**From:** Trish Cordova  
**Sent:** Thursday, February 27, 2020 12:59 PM  
**To:** Trish Cordova  
**Cc:** David Wage; Courtney Pal; Hang Zhou; Kim Salazar; Cliff Nguyen; Heather Lee; Joel Pullen; Wayland Li  
**Subject:** 2-27-20 PC Response to Commissioners' Questions  
**Attachments:** 200227 TI Docs.pdf

Planning Commissioners submitted the following questions regarding agenda items for the February 27, 2020 Planning Commission Agenda. Staff responses are included below:

### Item 2. Fremont Bank - PLN2019-00220

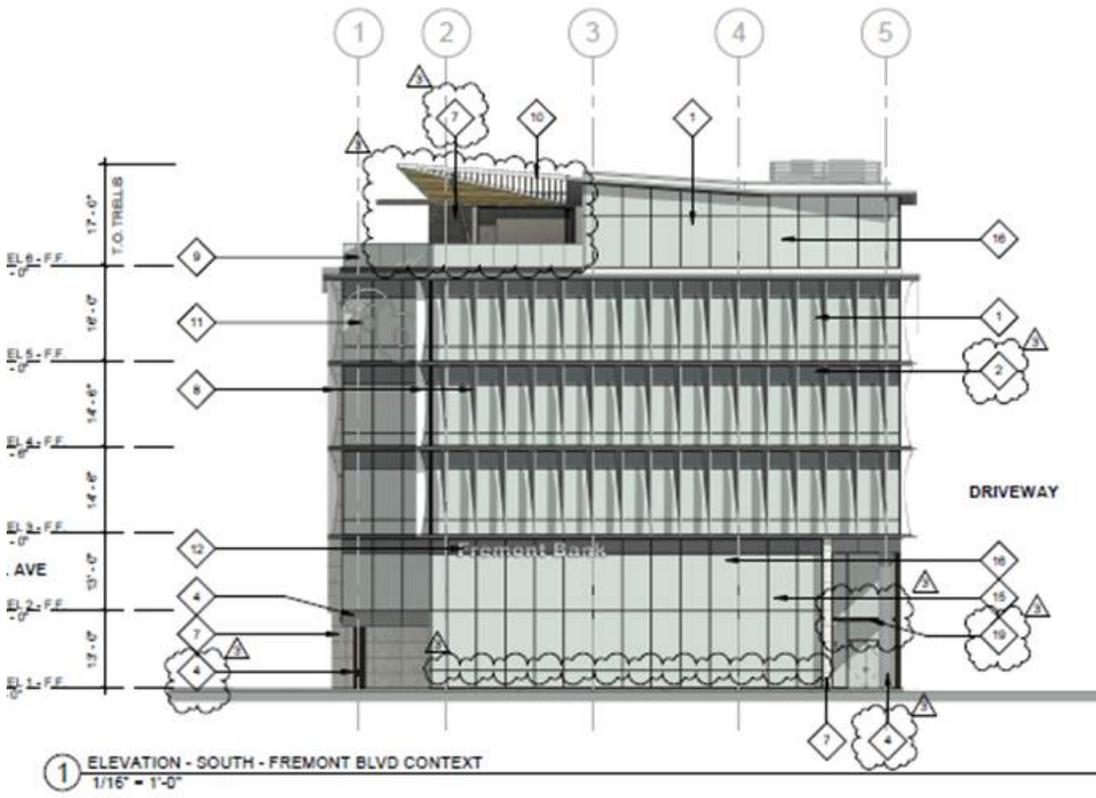
#### Commissioner Question: What is between the building and Fremont Boulevard? Is this parking?

**Staff Response:** Along Fremont Boulevard, the developer would remove the existing curb, gutter and sidewalk and construct a 16-foot-wide monolithic sidewalk with tree wells and pedestrian lighting in accordance with the Downtown Community Plan and Design Guidelines as shown below.

1 INTERIOR FLOOR PLAN - LEVEL 1  
1/4" = 1'-0"

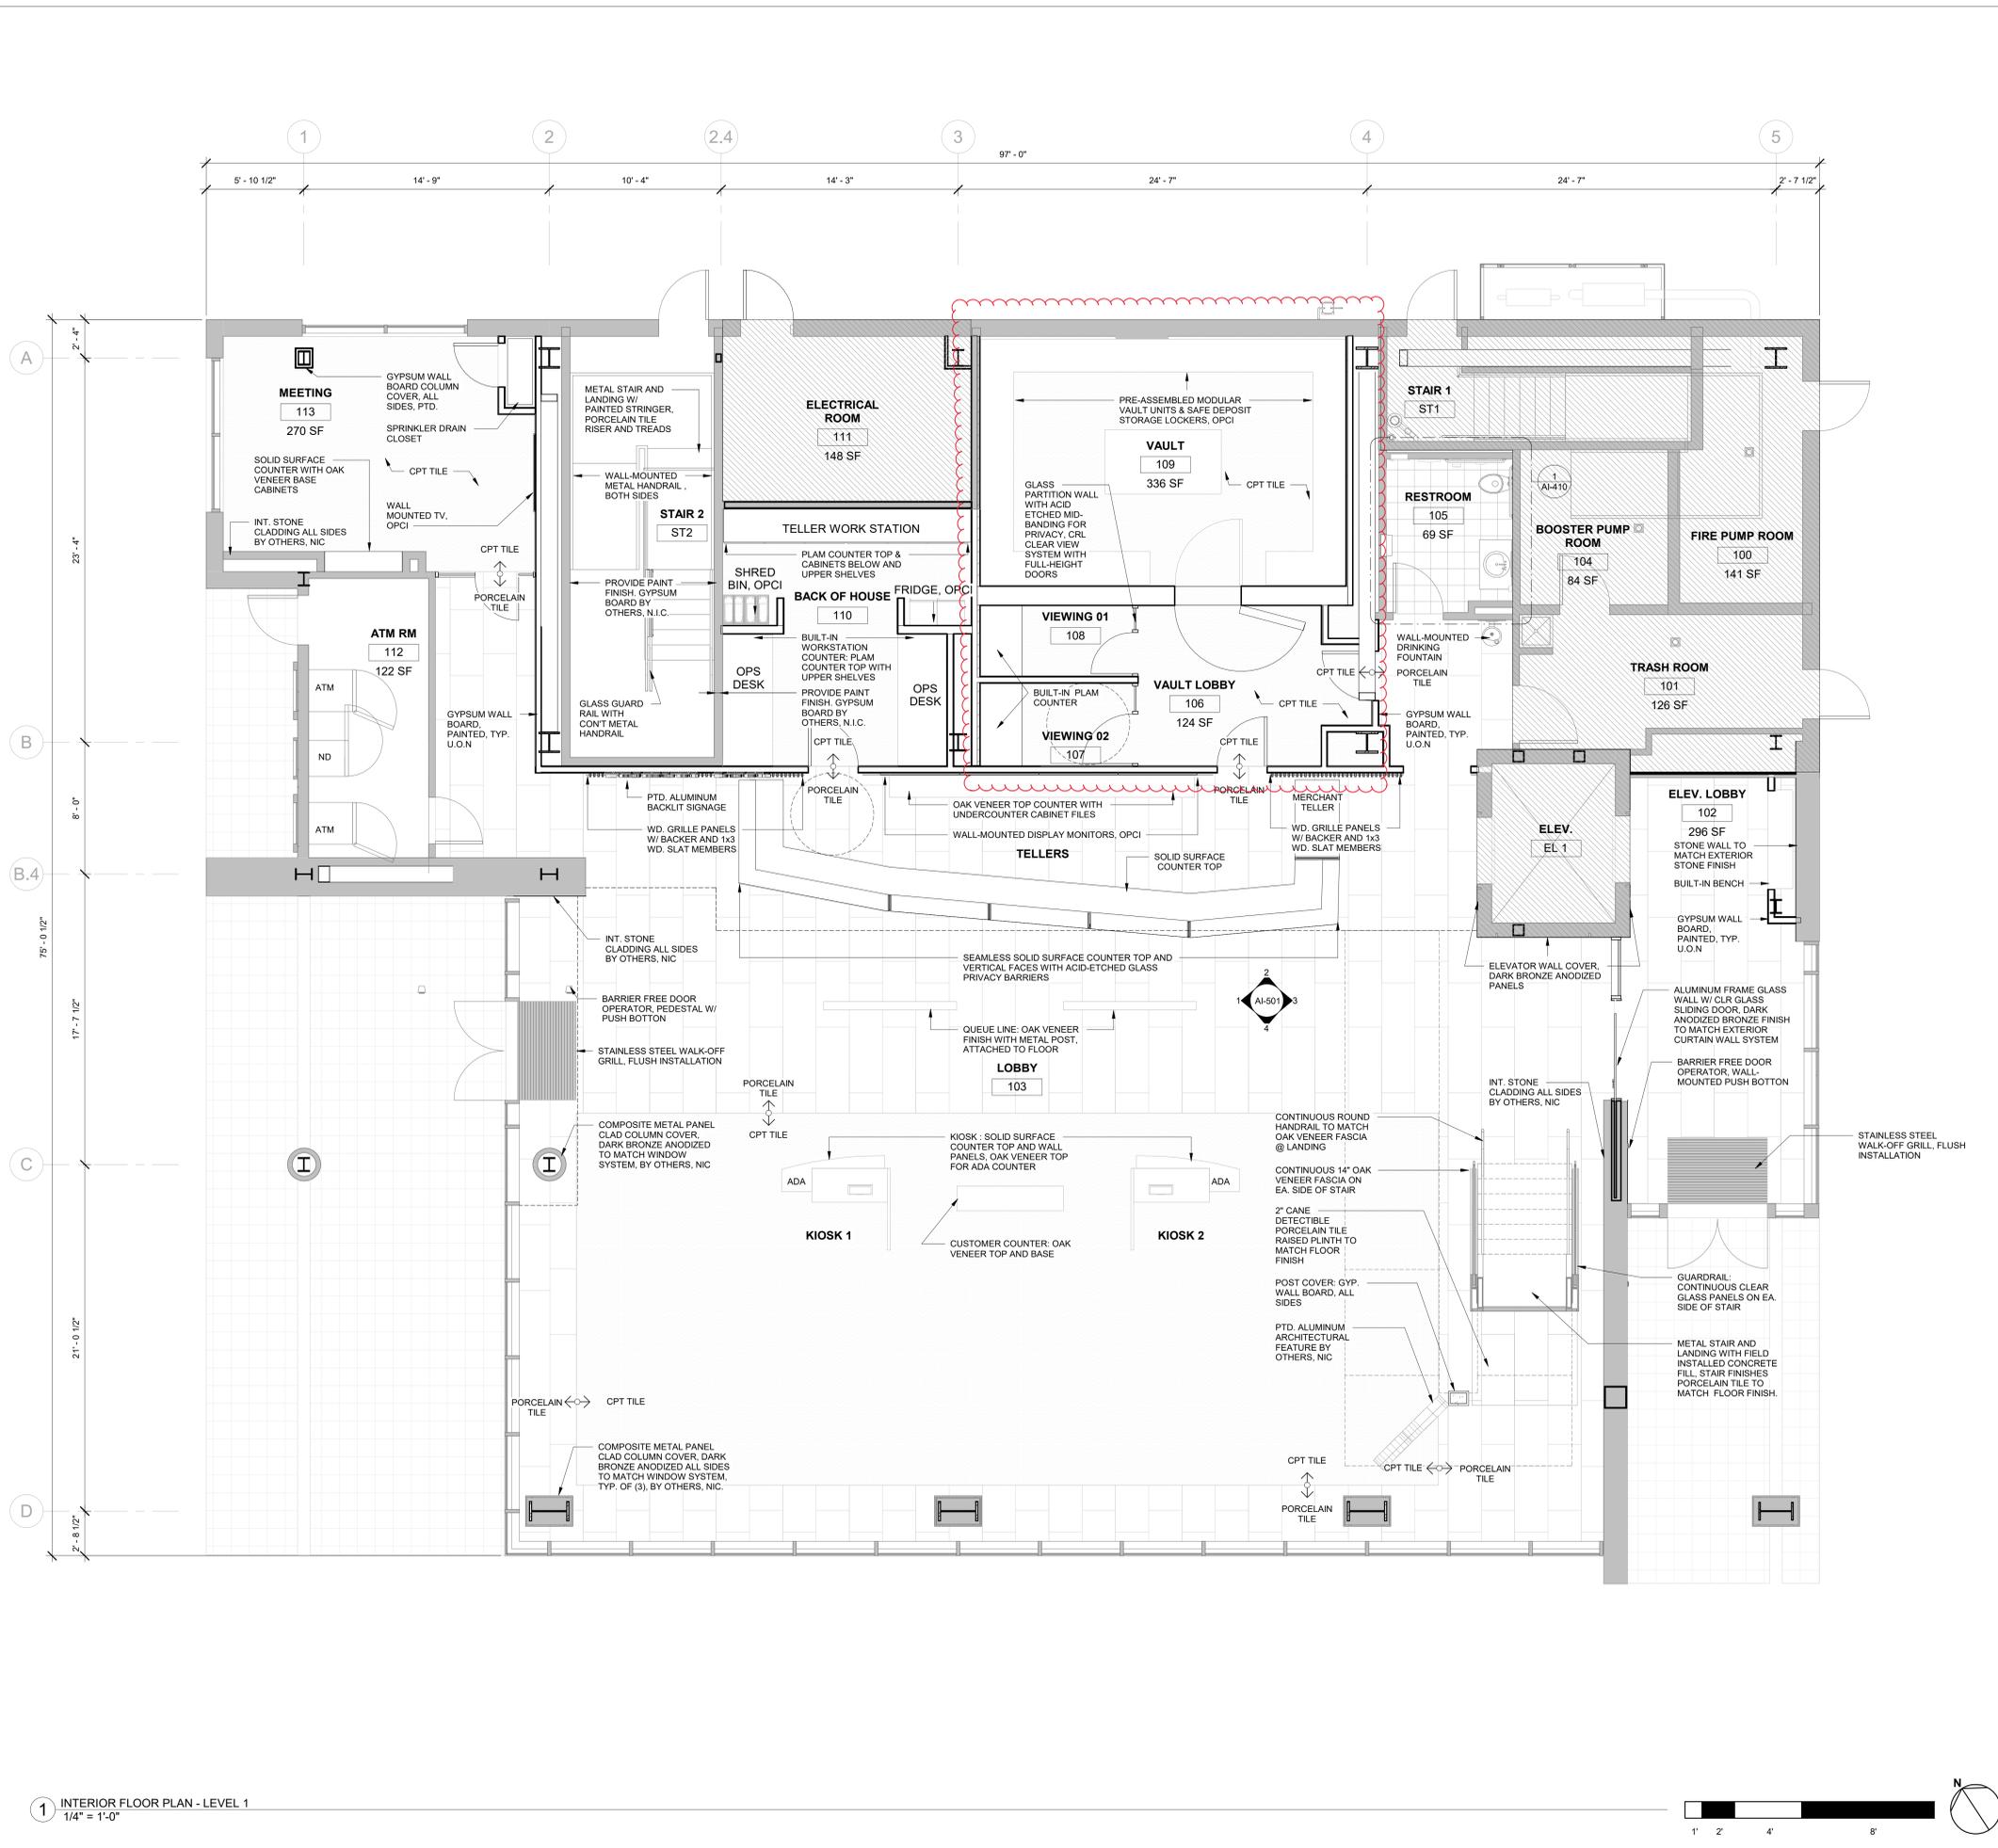
**Commissioner Question:** Will the bank have safe deposit boxes? What is expected to fill such a large space as the branch? Or on the office floors? Is there a dining room or kitchen on each floor? I recall that only 145 employees were expected on the site. That's ~250 sq ft/employee.

**Staff Response:** The ground floor has a vault, safe deposit boxes and viewing area for safe deposit boxes. Attached is a conceptual floor plan for the ground floor. Upper floors will provide offices for various bank functions such as mortgage lending, wealth management and bank management. There will be kitchen facilities on the 3rd, 4th and 6th levels.
